UNITED STATES PATENT AND TRADEMARK OFFICE

10/535,148

Office Action Summary	Application No. 10/535,148	Applicant(s) MIALHE, CLAUDE	
	Examiner ERIN COLELLO	Art Unit 4148

DETAILED ACTION

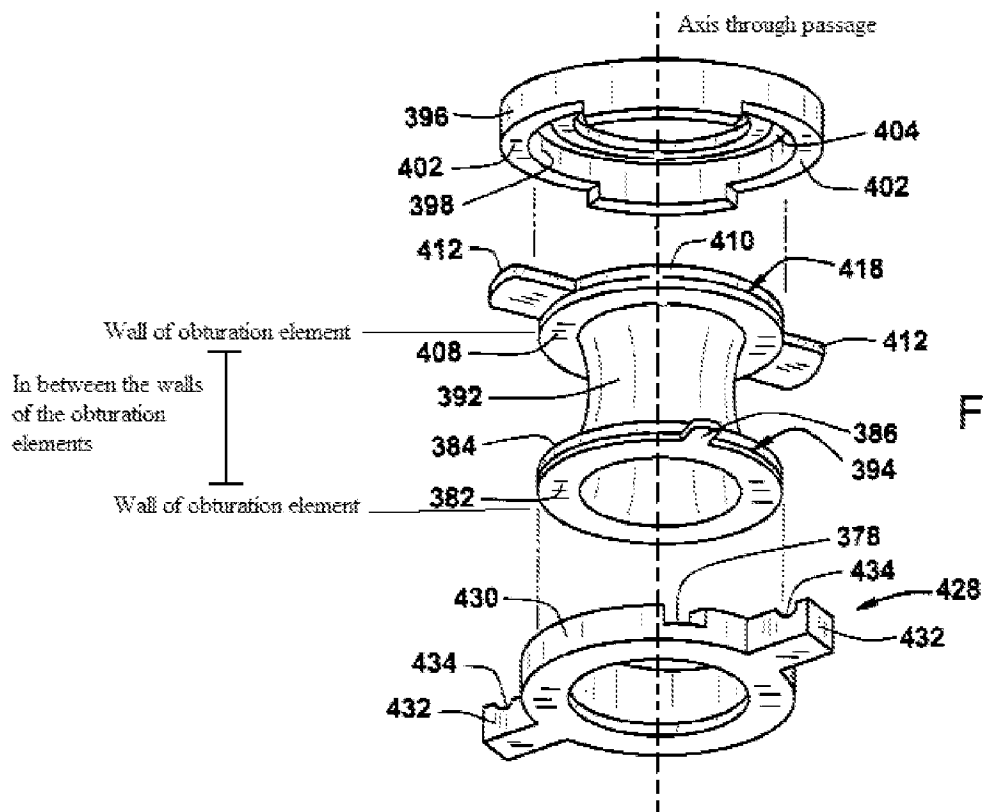
Regarding claim 1, De la Torre discloses an occlusive device for medical or surgical use, comprising a hollow cylindrical element (Figure 32, (392); Column 15, Lines 21-22) that can be twisted according to its axis to create a striction zone (Column 16, Lines 49-53), characterized in that it comprises two obturation elements (Figure 32, (410, 382)) integral to the inner wall of the cylindrical element (Column 15, Lines 40-42), leaving a passage (Figure 32 see below; Column 16, Lines 46-49) and arranged to press against each other to block the passage when the cylindrical element is twisted (Column 16, Lines 49-53).

Regarding claim 2, De la Torre discloses that the two obturation elements (Figure 32, (410,382)) are integral to two distinct areas of the length of the cylindrical element (Figure 32, (392); Column 15, Lines 40-42).

Regarding claim 4, De la Torre discloses that the two obturation elements (Figure 32 see below, (410, 382)) integral to two diametrically opposed areas of the wall of the cylindrical element (Figure 32, (392); Column 15, Lines 31-32, 40-42).

Regarding claim 6, De la Torre discloses that there are two end parts (Figure 32, (396,428)), surrounding the cylindrical element (Figure 32, (392)) and whose angular position determines the torsion of said cylindrical element (Column 15, Lines 39-43; Column 16, Lines 4-6, 50-53).

Regarding claim 8, De la Torre discloses that the obturation elements (Figure 32 see below, (410,382)) are applied one against each other by means of one of their lateral surfaces (Column 16, Lines 50-53, where inlet is closed because each obturation element is applied against each other)

Regarding claim 3, De la Torre discloses obturation elements (Figure 32, (410,382)) but fails to disclose obturation elements with a crescent-shaped cross section.

Regarding claim 10, De la Torre discloses two end parts (Figure 32, (396, 428)), surrounding the cylindrical element (Figure 32, (392)) and whose relative angular position determines the torsion of said cylindrical element (Column 15, Lines 39-43; Column 16, Lines 4-6, 50-53), said end parts possessing means of attachment to the wall of a vessel (Column 17, Lines 27-31). De la Torre fails to disclose that both end parts have means of attachment to the wall of the vessel.

It would have been obvious to one having ordinary skill in the art at the time the invention was made to modify the end part (396) with the end part (428) which possess means of attachment to the wall of the vessel since it has been held that mere duplication of the essential working parts of a device involves only routine skill in the art. St. Regis Paper Co. v. Bemis Co., 193 USPQ 8.

Regarding claim 12, De la Torre discloses a seal (Figure 32, (428)) on the outer surface of at least one of the expanding elements (Column 17, Lines 27-31, where the suture is the expanding element), said seal being appropriate for application to the wall of a vessel, (Figure 32, (428) where the seal is formed between the vessel wall and the device by suturing).

Regarding claim 15, De la Torre discloses a removable sheath (Figure 32, where sheath is the outside surface of the cylindrical member (392)) inserted between the wall of the obturation elements (Figure 32, (410, 382) see below) and the external wall of the guide (Column 16, Line 54, where a removable guide is the object inserted).
